ITEM NO.	506.55	BRIDGE NO.	44	PROJ. NO.	BRS-RS 0113 (8)													
TITLE:	CAMBER DIAGRAM ~ G1B THRU G7B																	
APPROVED:

PRINT DIST.	5	10-12-96	APPR	 National Eastern Corporation Plainville, Connecticut	ORC	5	11-5-96	FAB		5	11-18-96	APP
PRINT DIST.	5	10-12-96	APPR	 National Eastern Corporation Plainville, Connecticut														
ORC	5	11-5-96	FAB															
	5	11-18-96	APP															
JOB:	U.S. ROUTE 5 OVER BLACK RIVER SPRINGFIELD, VERMONT																	
CUSTOMER:	WINTERSETT, INC.																	
DESIGNER:	VERMONT AGENCY OF TRANSPORTATION																	
WORK ORDER NO.	15713	DRAWING NO.	10-5	REV.														
CHECKED	10/9/96	MSD																
DRAWN	9/96	CSD

CAMBER DIAGRAMS ~ G1B THRU G7B

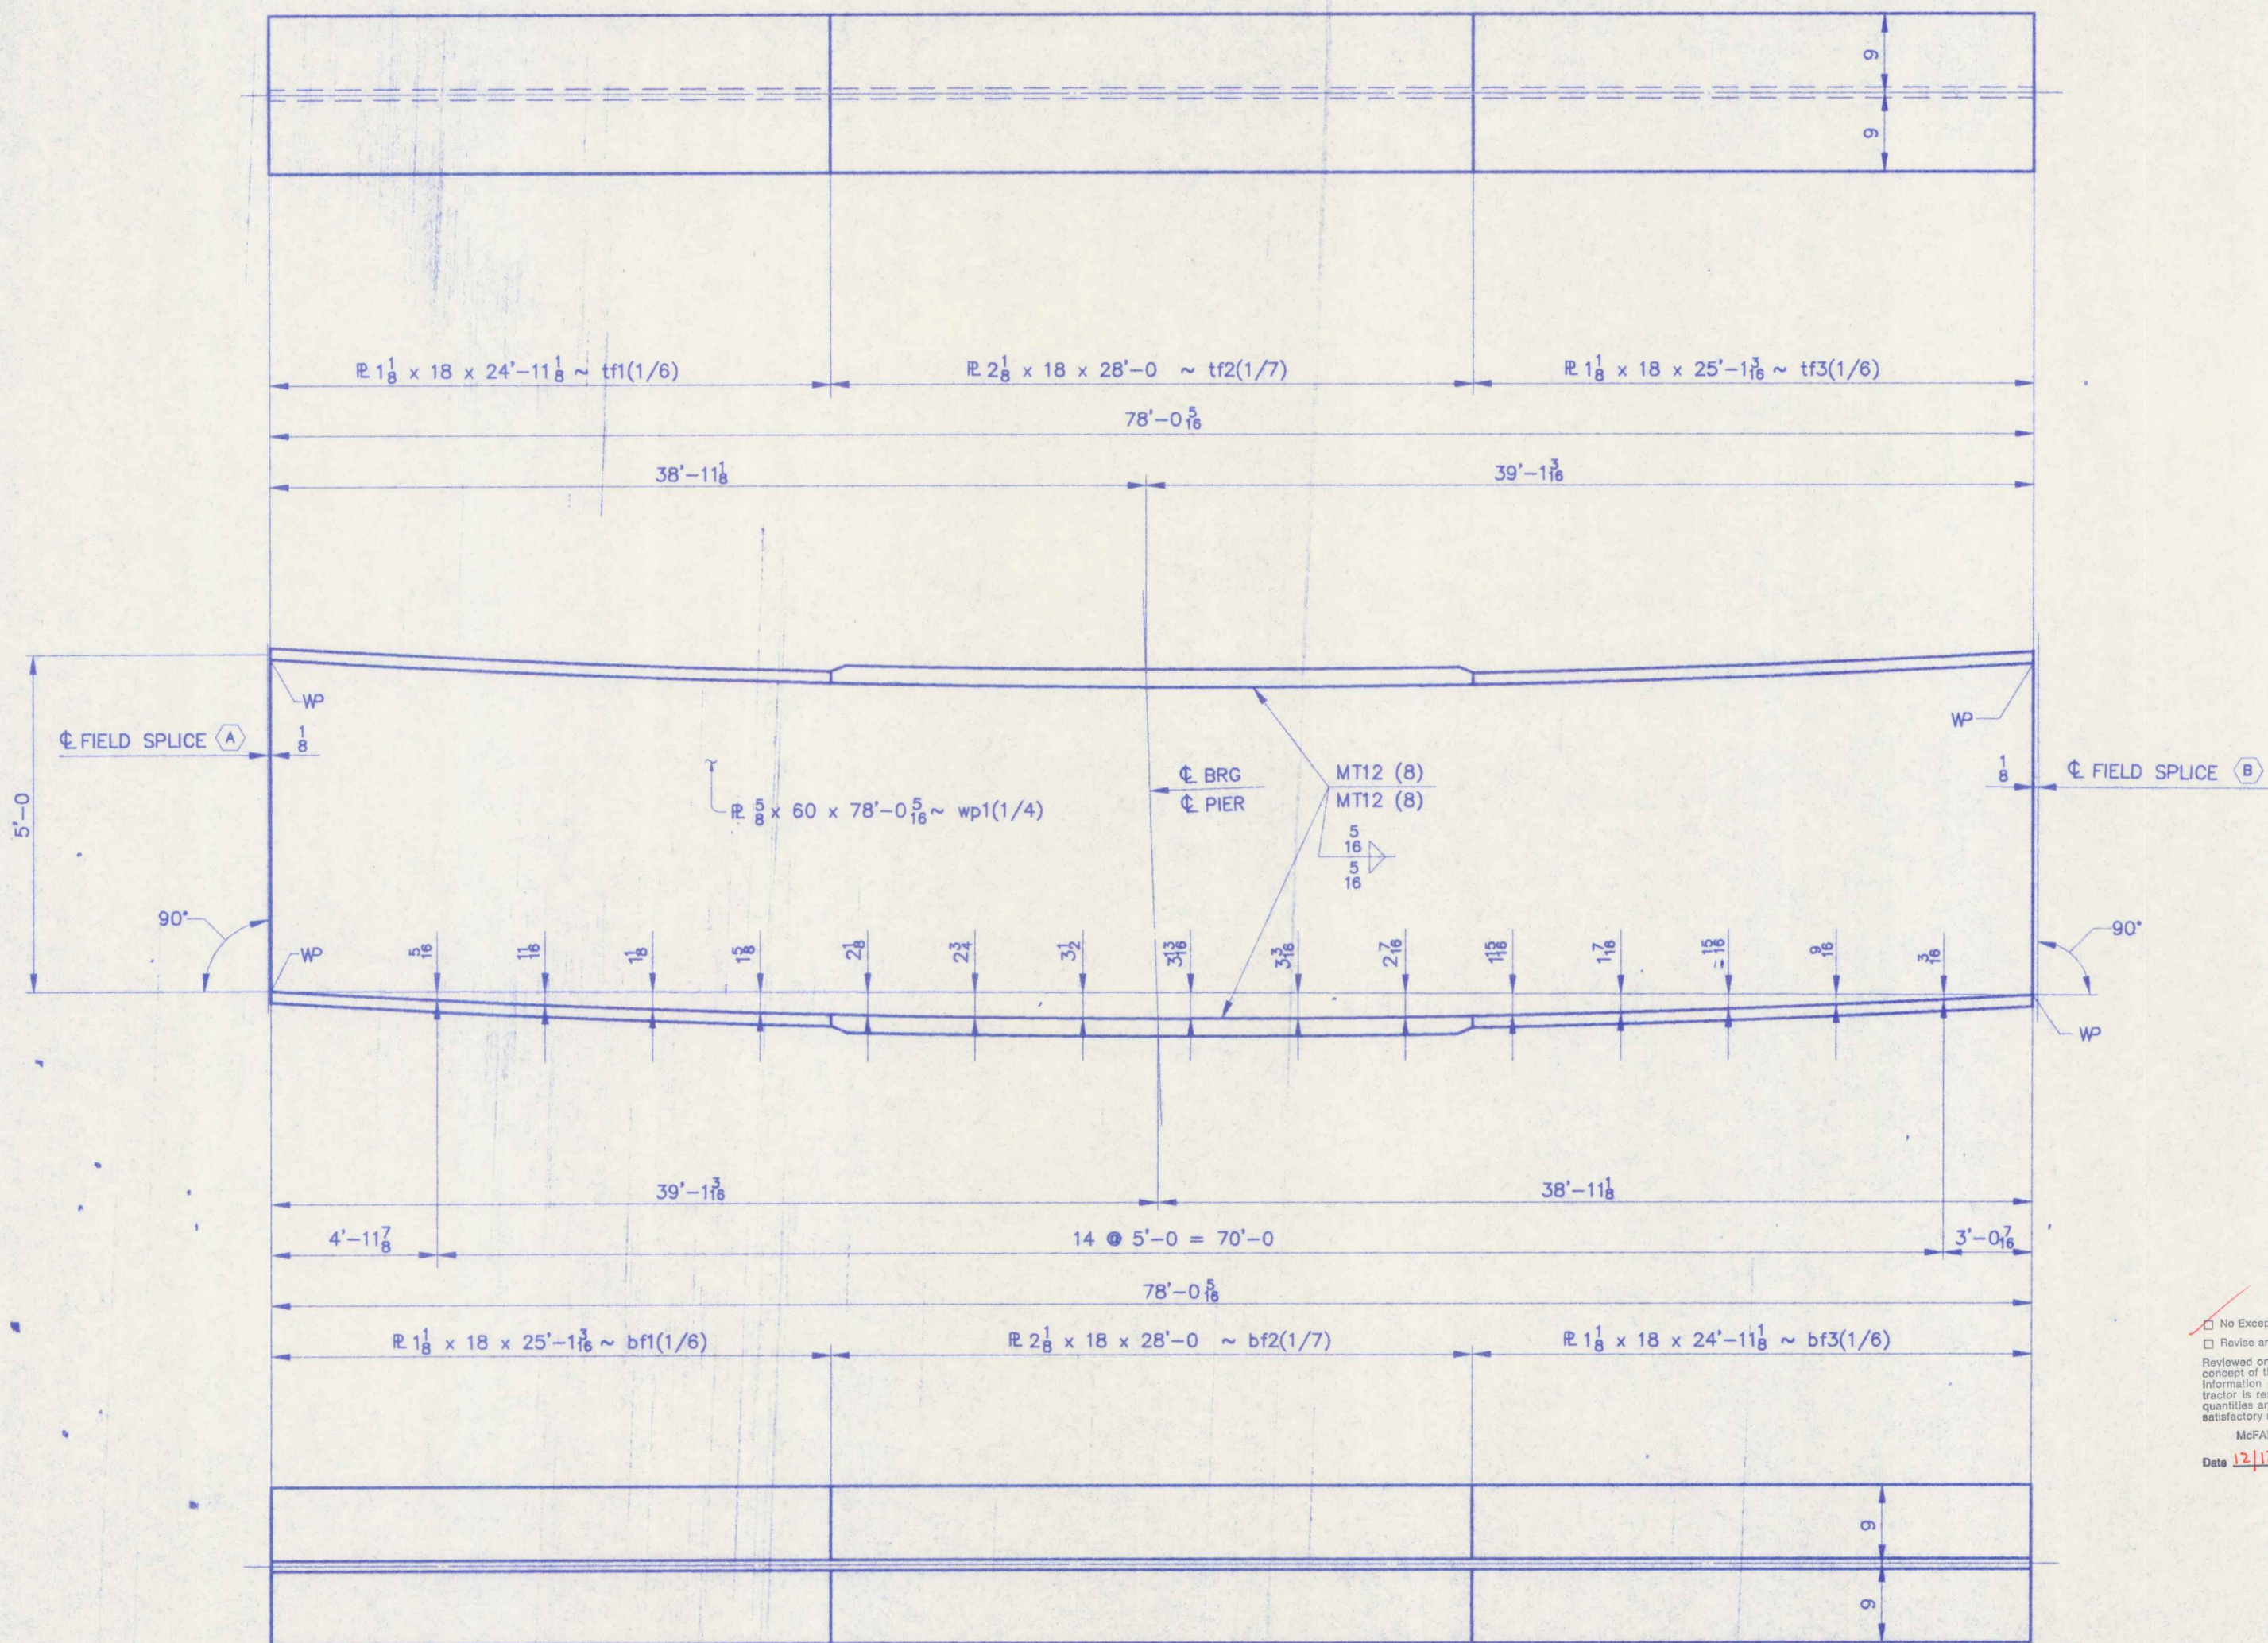
No Exception Taken Make Corrections Here
 Review and Re-submit Not Applicable
 Reviewed only for general conformity with the design
 portion of the project and cannot constitute a warranty
 or assurance of any kind for controlling and executing all
 quantities and dimensions and performing the work in a
 satisfactory manner.
 MAZURKOWSKI ENGINEERS, INC.
 Date 12/12/96 BY [Signature]
